STATE OF HAWAII
DEPARTMENT OF TRANSPORTATION
HIGHWAYS DIVISION

ROADWAY DETAILS

KAHEKILI HIGHWAY WIDENING
Likelike Hwy. to Vicinity of Haiku Road
F.A. PROJECT NO. NH-083-1(26)

TERMINAL CONNECTOR DETAIL
SCALE: 3/4" = 1'-0"

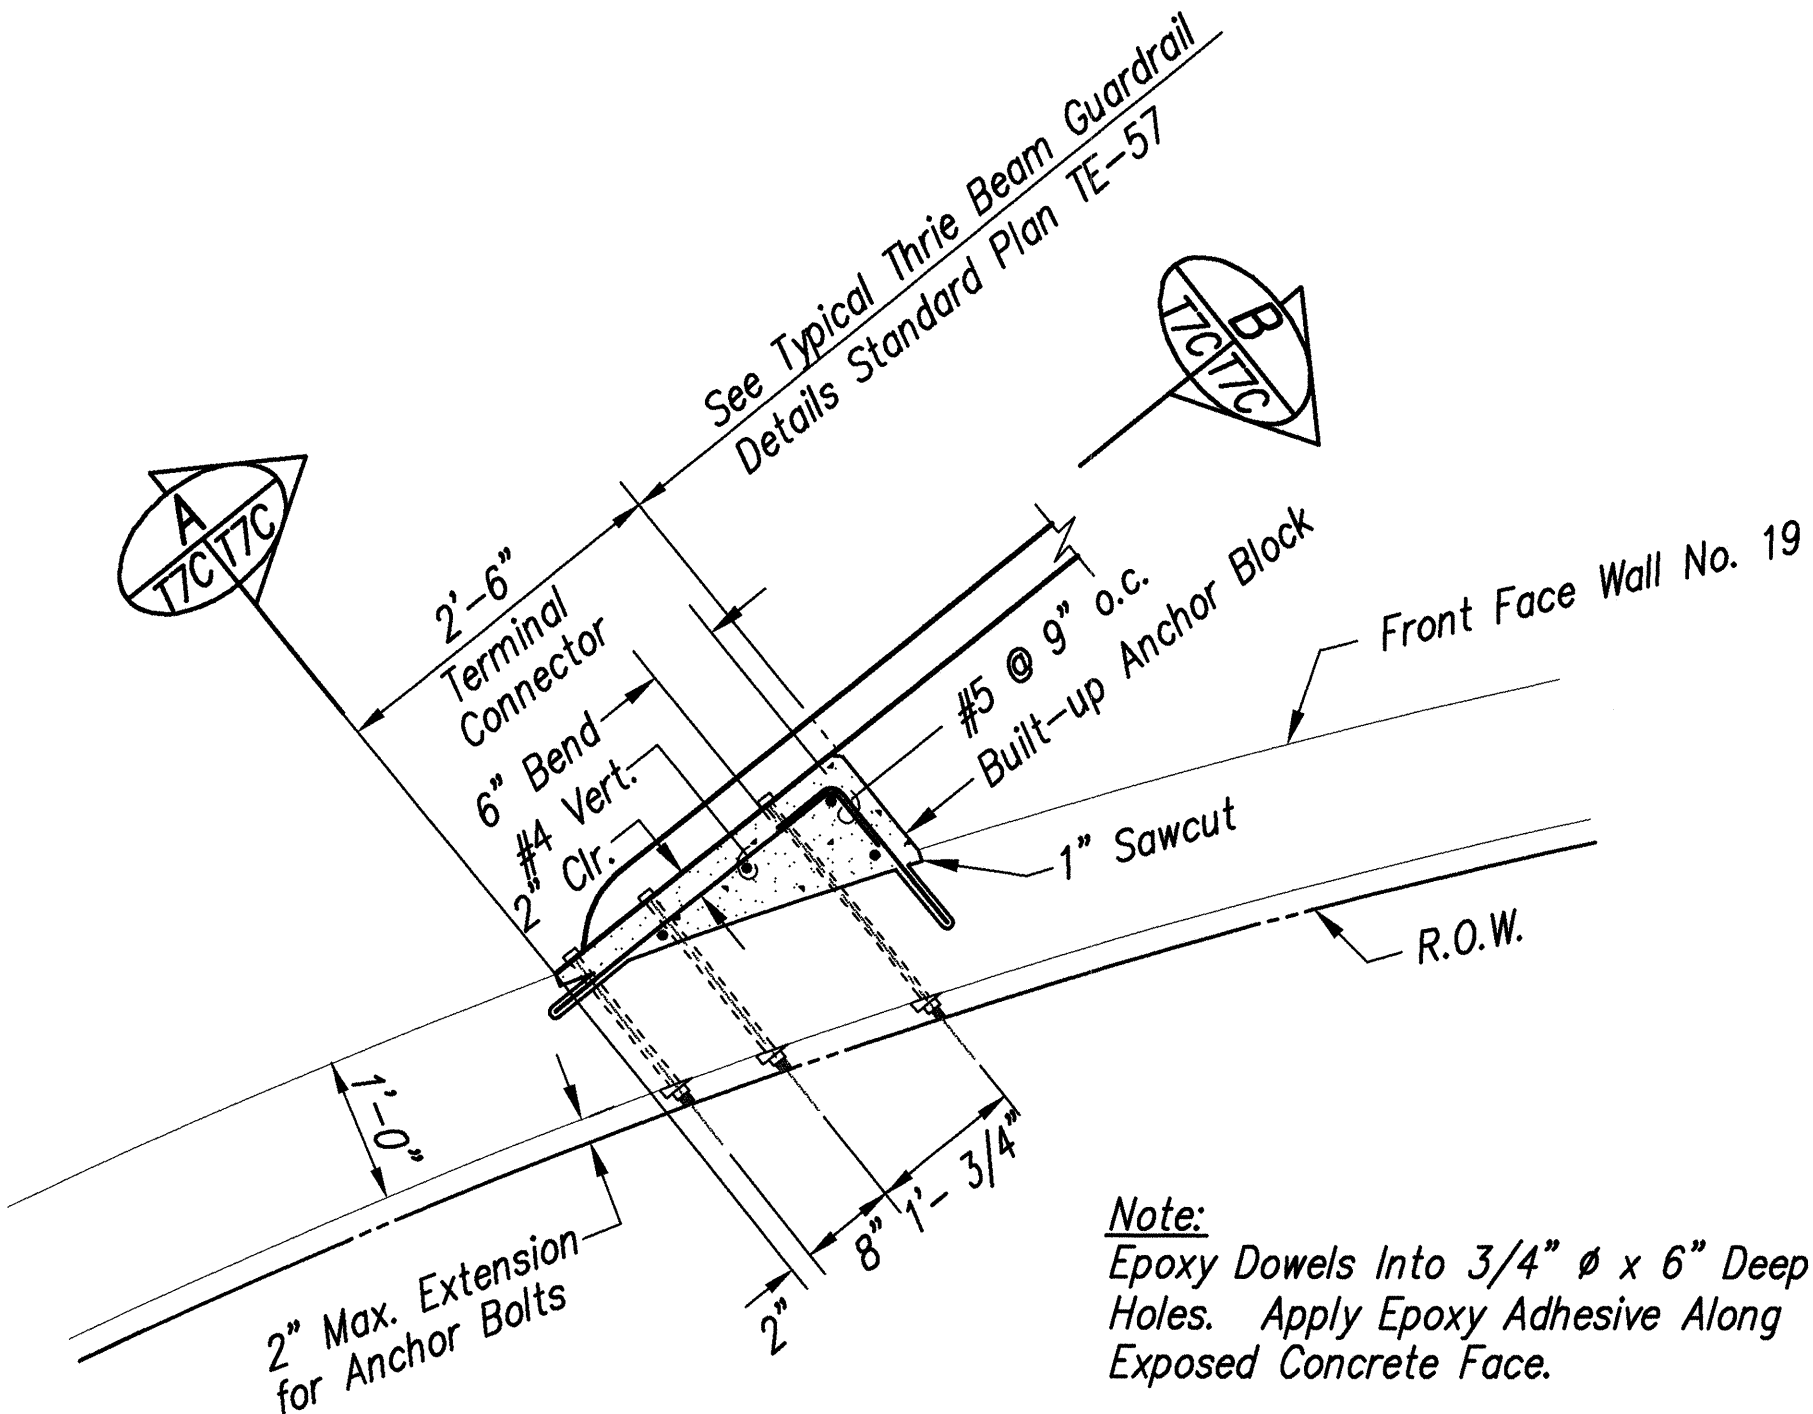
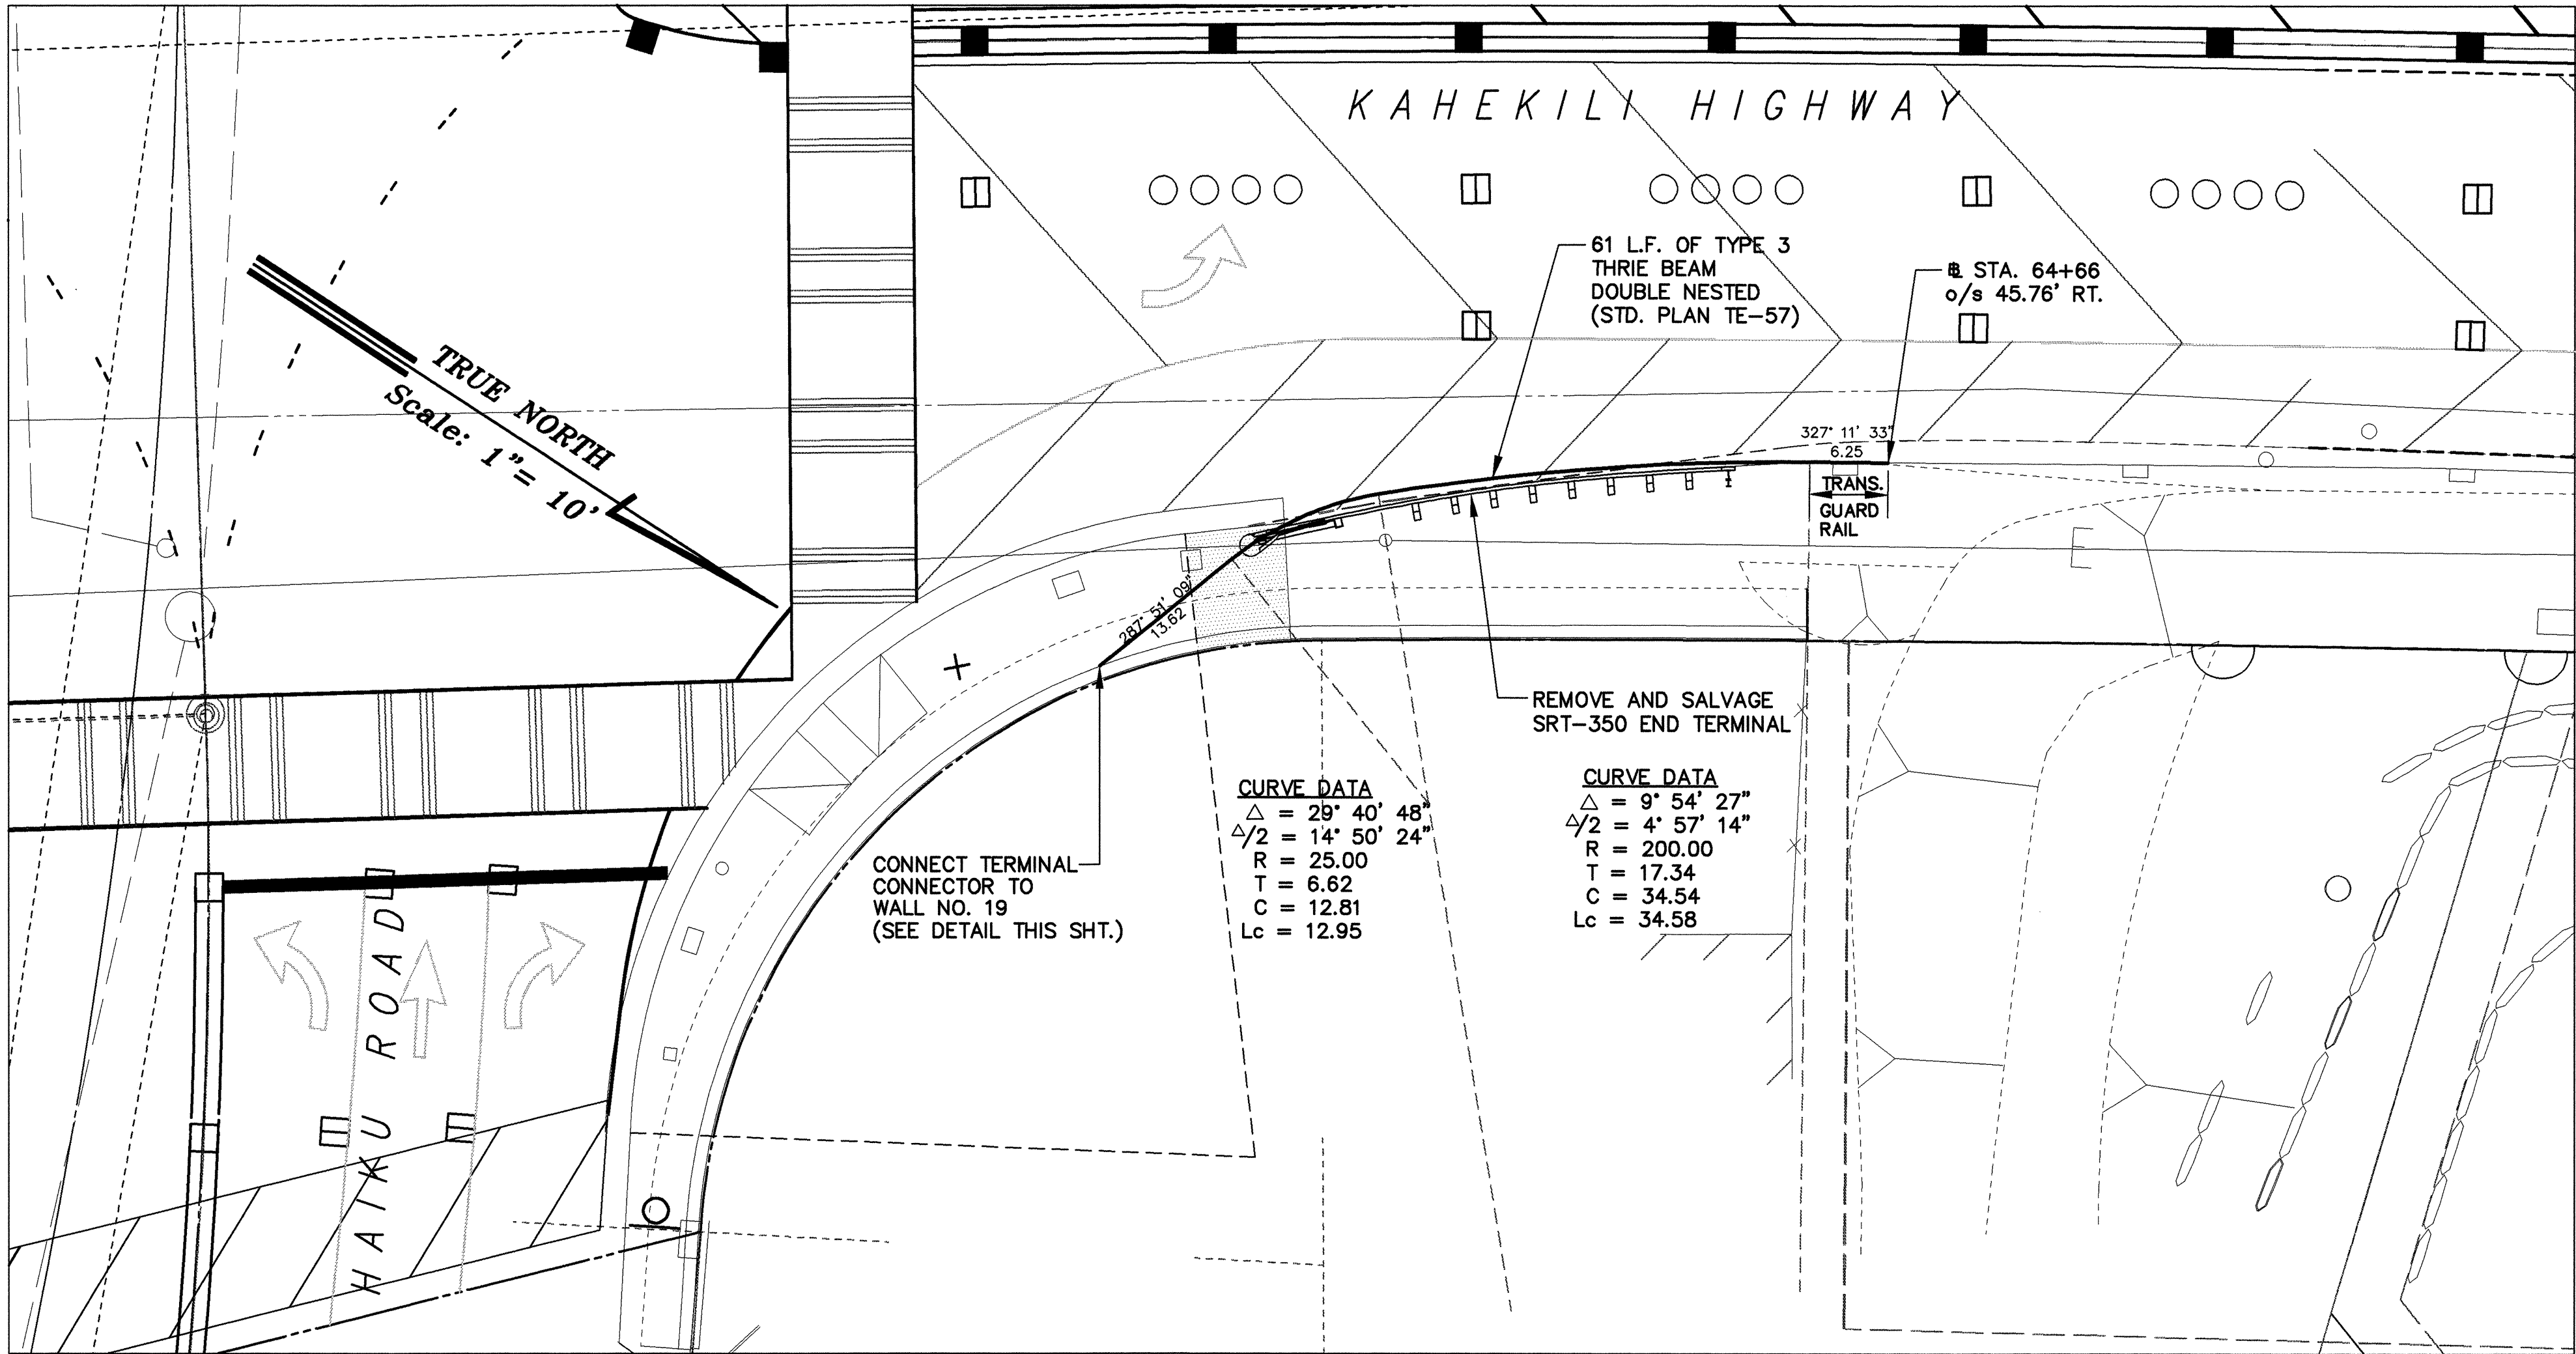
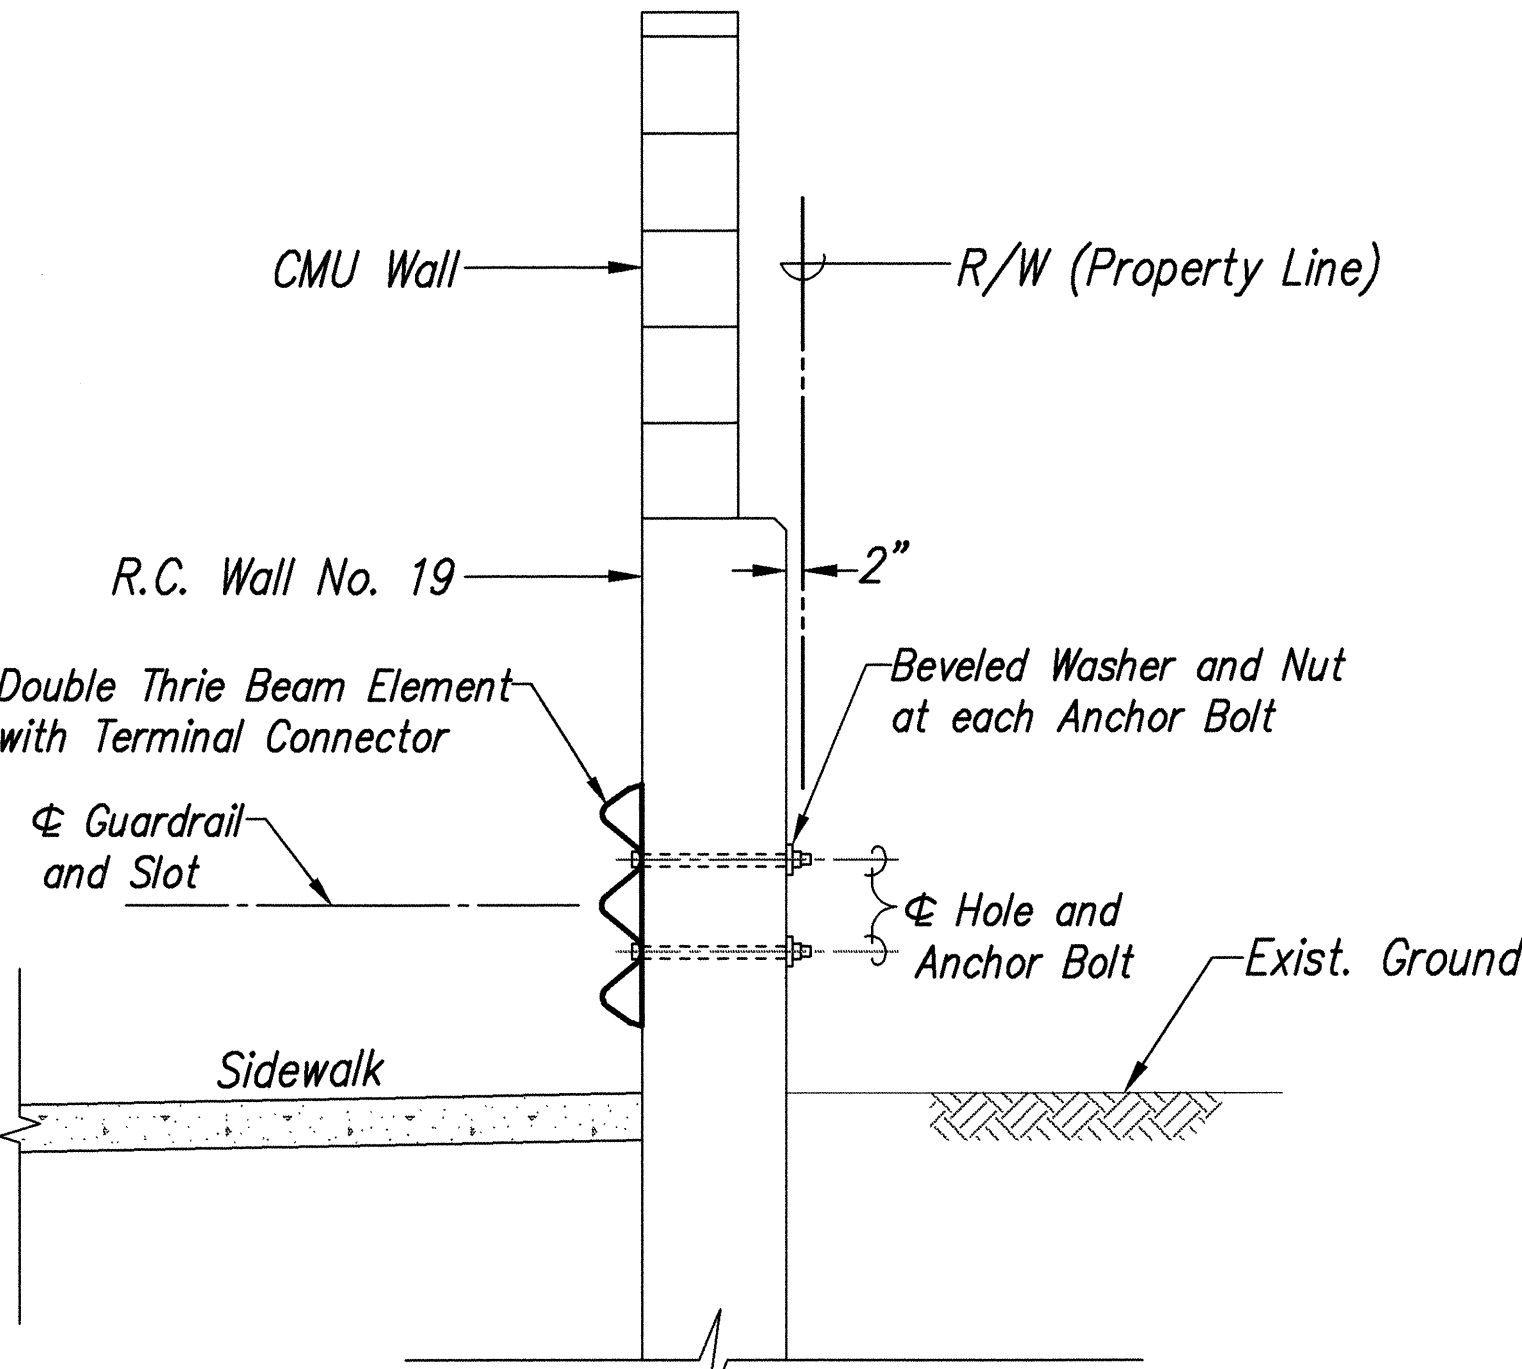
12/16/97	REPLACE SRT-350 WITH THRIE BEAM WITH WALL TERMINAL CONNECTOR.
DATE	REVISION
